CMD 26-M10.B

**Status of licensee research and  
development commitments on  
elevated hydrogen equivalent  
concentration in pressure tubes**

Subject CNSC Staff Clarifications Concerning CMD 26-M10.3  
Sujet Clarifications du personnel de la CCSN concernant CMD 26-M10.3

**Attachment A: CNSC staff clarifications to intervenor comments from CMD 26-M10.3**

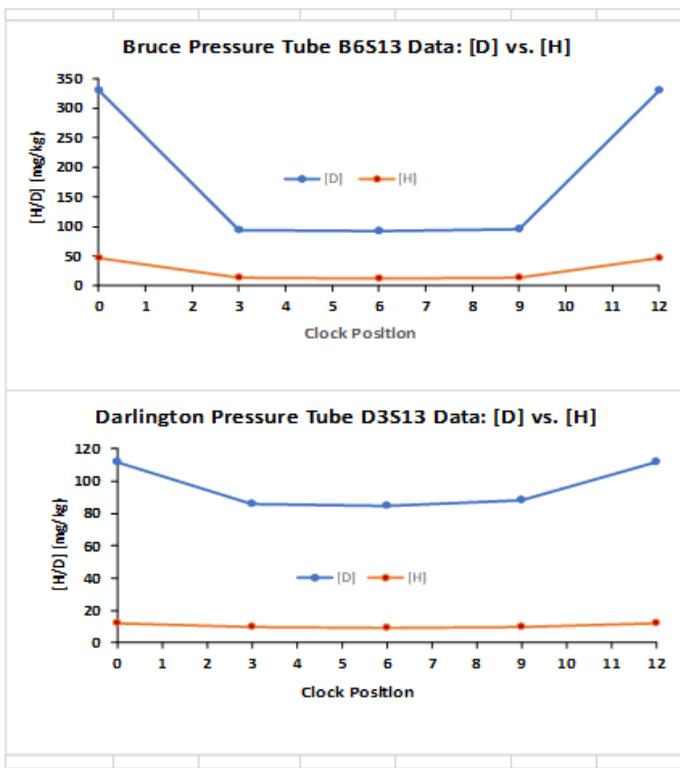
<p>Intervenor Comments from <a href="#">CMD 26-M10.3</a>            Commentaires par un intervenant dans <a href="#">CMD 26-M10.3</a></p>	<p>CNSC Staff Clarifications</p>	<p>Précisions du personnel de la CCSN</p>
<p><b>Figure 10: Deuterium Concentration Ratio <math>[D_{12}]/[D_6]</math> vs. <math>\Delta T = (T_8 - T_{12})</math></b></p>  <p>This formalism was previously used to analyze [H] and [D] concentration data in the P3LSFCR sample set at different clock positions and locations approximately 150 mm from the pressure tube outlets – see for example, OHRD 1994 Report A-NFC-94-115-K. For this particular case the observed <math>[D_{12}]/[D_6]</math> ratios were in the range <math>1.18 \pm 0.06</math> corresponding to a <math>\Delta T</math> of 20 °C which is in good agreement with predictions of <math>\Delta T</math> for a CANDU reactor after 12 EFPY of Unit operation.</p> <p>Similar H/D data for a Darlington pressure tube, (D3S13), after 25 EFPY was recently reported by OPG – See the July 2021 OPG Memo: NK38-CORR-31100-0934854. For this pressure tube, data are reported at distances between 8- and 120-mm inboard of the outlet rolled joint and at several different circumferential (clock) positions. The observed <math>[D_{12}]/[D_6]</math> ratios for these samples are in the range <math>1.25 \pm 0.05</math> corresponding to a <math>\Delta T</math> of about 25 °C. Once again, these values are in good agreement with predictions of <math>\Delta T</math> for a CANDU reactor after 25 EFPY of Unit operation.</p>

<b>Intervenor Comments from <a href="#">CMD 26-M10.3</a> Commentaires par un intervenant dans <a href="#">CMD 26-M10.3</a></b>	<b>CNSC Staff Clarifications</b>	<b>Précisions du personnel de la CCSN</b>
<p>Turning now to [H/D] data for a Bruce pressure tube, namely B6S13, (See OPG Memo: NK38-CORR-31100-0934854), we find the observed [D12]/[D6] ratio is about 3 which gives a physically unrealistically high value &gt; 60 °C for the corresponding <math>\Delta T</math>. This indicates that an additional, (non-thermally activated), process is involved in the H/D ingress into the B6S13 pressure tube. This conclusion is supported by the behavior of H (light hydrogen) in the B6S13 sample which is quite different to the behavior of H in the D3S13 sample, as shown in Figure 11, below. This, once again, is a good indication of an additional source of H/D for the B6S13 sample.</p>

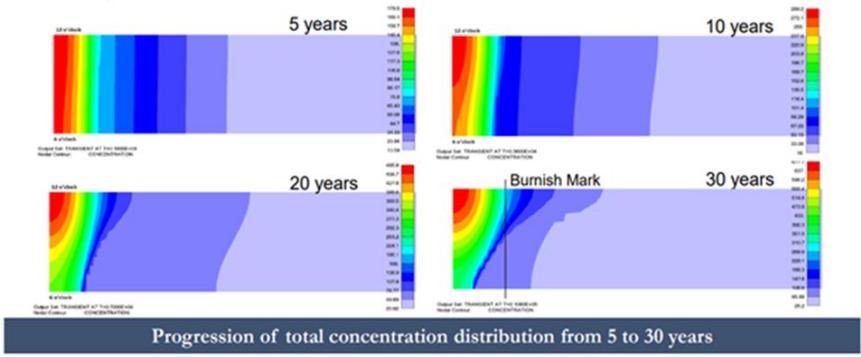
<p>However, it is acknowledged that there are examples of pressure tubes in other CANDU reactors that <i>are</i> consistent with H/D entry solely from the heat transport system. Thus, consider the H/D data reported in the July 2021 OPG Memo: NK38-CORR-31100-0934853 for the Darlington pressure tube D3S13, as shown in Table 7, below. The calculated [H] values in the Table are derived assuming an average [H<sub>init</sub>] of 10.5 mg/kg for the three samples of interest.</p>	<p>The Heq for the measurement locations is below the solubility limit of the material, so the measurements are not impacted by the ratcheting phenomenon and all hydrogen present is free to diffuse at full power operating temperatures. Therefore, these measurements are less impacted by circumferential temperature gradients than the B6 tube measurements</p>	<p>La concentration de Heq aux emplacements des mesures est inférieure à la limite de solubilité du matériau, de sorte que les mesures ne sont pas affectées par le phénomène de rochetage et que tout l’hydrogène présent peut se diffuser librement aux températures d’exploitation à pleine puissance. Par conséquent, ces mesures sont moins affectées par les</p>

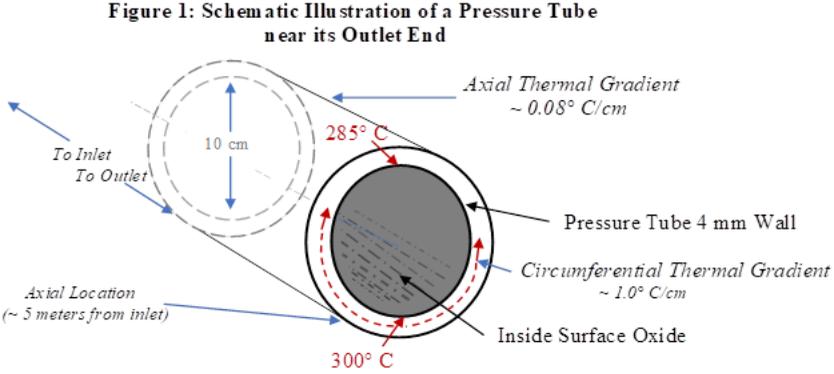
<p><b>Issues of Concern:</b></p> <p>1. For my first issue I wish to address some of the material presented by Bruce Power on September 10<sup>th</sup>, 2021, at CNSC Public Hearing CMD 21-H11.2A. Specifically, I am especially interested in Slide No. 20 from this Hearing – as shown below:</p>	<p>The information provided in <a href="#">CMD 21-H11.2A</a> was not developed from a fully validated model and was an early attempt at explaining the observations from tube B6S13. At the time it was presented, CNSC staff expressed similar comments to the Commission noting that a significant research effort would be required to verify and validate such a model.</p> <p>The industry research and development program deliverables addressed verification, validation and sensitivity studies. The reports documenting this information are proprietary to the licensee so specific details are not shared by CNSC staff in <a href="#">CMD 26-M10</a>. However, some of the work has been published in the public domain <a href="#">CMD 21-H11.2A</a>.</p>	<p>Les renseignements fournis dans le <a href="#">CMD 21-H11.2A</a> n’ont pas été produits à partir d’un modèle entièrement validé et constituaient une première tentative en vue d’expliquer les observations associées au tube B6S13. Lorsque ces renseignements ont été présentés, le personnel de la CCSN a formulé des commentaires semblables à l’intention de la Commission, soulignant qu’un effort de recherche important serait nécessaire pour vérifier et valider un tel modèle.</p> <p>Les livrables du programme de recherche et développement de l’industrie portaient sur la vérification, la validation et les études de sensibilité. Les rapports documentant ces renseignements sont la</p>

<p>Intervenor Comments from <a href="#">CMD 26-M10.3</a>                      Commentaires par un intervenant dans <a href="#">CMD 26-M10.3</a></p>	<p>CNSC Staff Clarifications</p>	<p>Précisions du personnel de la CCSN</p>
<p><b>Rolled Joint Ingress</b>  <b>Temperature Gradient</b></p>  <p>Progression of total concentration distribution from 5 to 30 years</p> <p>BrucePower Innovation at work</p> <p>20</p> <p>Slide No. 20 is entitled: “Temperature Gradient” – suggesting it could provide some insight into the alleged hydrogen redistribution phenomenon; but most remarkably, <u>no temperature gradient data whatsoever are provided by Slide 20</u>. Instead, we are presented with hydrogen concentration profiles calculated for a generic pressure tube outlet rolled joint after 5, 10, 20 and 30-years of Unit operation, <u>with no indication as to how these concentration profiles were determined</u>. Worse yet, <u>the magnitude of the alleged temperature gradient is not even mentioned in Slide 20</u>, and neither is any information provided as to the values of the diffusion coefficients and H/D ingress rates that must have been used to calculate these concentration profiles. However, regardless of the paucity of useful information provided by Slide 20, we know that Bruce Power’s so-called “predictive model” for [Heq] in operating pressure tubes has been <u>seriously in error</u> for many years. By way of acknowledging this problem, Bruce Power agreed back in July 2021 to undertake the “development of a predictive model accounting for elevated [Heq] and</p>		<p>propriété exclusive des titulaires de permis. Par conséquent, le personnel de la CCSN n’a pas inclus de renseignements précis dans le <a href="#">CMD 26-M10</a>. Toutefois, certains des travaux ont été publiés dans le domaine public <a href="#">CMD 21-H11.2A</a>.</p>

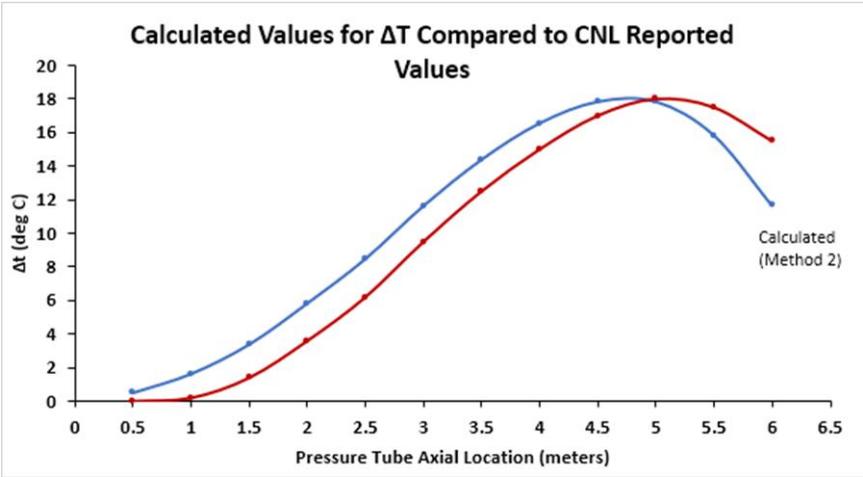
Intervenor Comments from <a href="#">CMD 26-M10.3</a> Commentaires par un intervenant dans <a href="#">CMD 26-M10.3</a>	CNSC Staff Clarifications	Précisions du personnel de la CCSN
<p>It is assumed that:</p> $\Delta T(x) = \Delta T_6(x) + \Delta T_{12}(x)$ <p>Where x is the axial distance (in meters) from the pressure tube inlet, (x = 0), to outlet, (x = 6).</p> <p><b><u>Determination of <math>\Delta T_6</math>:</u></b>  <math>\Delta T_6</math> depends on the bundle power, usually expressed in kW, at a given axial location. I have used bundle power data from a Bruce B Safety Report for a high power, (7.5 MW), channel to derive a dimensionless axial power profile, P(x), over the full 6-meter reactor core, with the data points normalized to the maximum channel power of 1035 kW at the 3-meter axial location. It is assumed that <math>\Delta T_6</math> may be approximated by the simple relationship:</p> $\Delta T_6(x) = C_1 \times P(x)$ <p>Where <math>C_1</math> is a proportionality constant, (in units of °C), between the excess pressure tube wall temperature and the local fuel bundle output power – a conversion factor to be determined.</p> <p>Using published data derived from CANDU reactor thermal hydraulic codes such as ASSERT-PV, <math>C_1</math> is estimated to be 10 °C.</p> <p><b><u>1. Determination of <math>\Delta T_{12}</math>:</u></b>  <math>\Delta T_{12}</math> depends on the amount of pressure tube diametral expansion induced by neutron induced creep. CNL has published plots of the amount of diametral expansion, D(x), along the axial length of a pressure tube, (See R. B. Adamson et al. in Journal of Nuclear Materials Vol. 521, 167 – 244, (2019). It is assumed that <math>\Delta T_{12}</math> may be approximated by the simple relationship:</p> $\Delta T_{12}(x) = C_2 \times D(x)$

Intervenor Comments from <a href="#">CMD 26-M10.3</a> Commentaires par un intervenant dans <a href="#">CMD 26-M10.3</a>	CNSC Staff Clarifications	Précisions du personnel de la CCSN																																																																						
<p>Where <math>C_2</math> is a proportionality constant, (in units of °C), between the amount of pressure tube wall temperature cooling and the neutron-induced pressure tube diametral expansion normalized to its maximum value which is well in-board of the mid-core, 3-meter location. For this intervention I have used a value of 8 °C for <math>C_2</math>.</p> <p>Combining these parameter values with axial power profile and the diametral expansion data noted above we are able to calculate <math>\Delta T(x)</math> for a set of axial locations from <math>x = 0</math> to <math>x = 6.0</math> meters, as shown in Table 1, below, together with <math>\Delta T</math> values taken from CNL's 2016 report.</p> <p><b>Table 1: Calculated <math>\Delta T</math>s at Different Axial Locations vs. CNL's Published Data</b></p>
